## Federal Recall Information

10KWE

Kenworth Truck Company

T660 Hood Strut Safety Latch

Figure 2

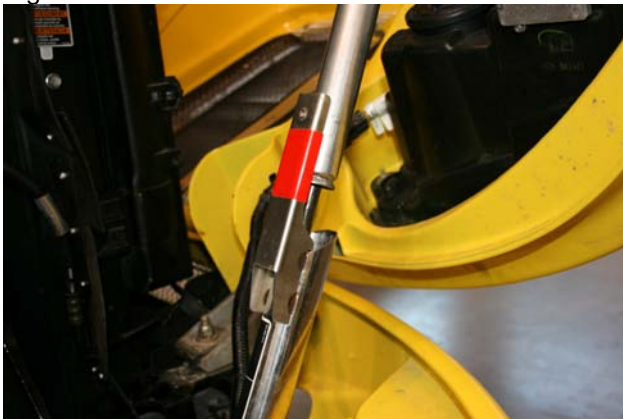
The retaining pins securing the hood strut lock tube to the hood strut assembly may become loose and fall out allowing the lock tube to rotate on the strut assembly (ref. Figure 1).

In normal operation the safety latch feature is automatically set and prevents the hood from closing (ref. Figure 2). With the hood closed and the retaining pins missing, the lock tube may rotate relative to the hood strut resulting in a non-operational safety latch feature when the hood is opened (ref. Figure 3). A non-operational safety latch feature may not be detected by an operator increasing the risk of personal injury and/or vehicle damage should the hood unexpectedly close.

The remedy of the recall involves replacement of the pivot disc and lock tube retaining pins with a revised pivot disc and cap screws (see attached repair procedure).
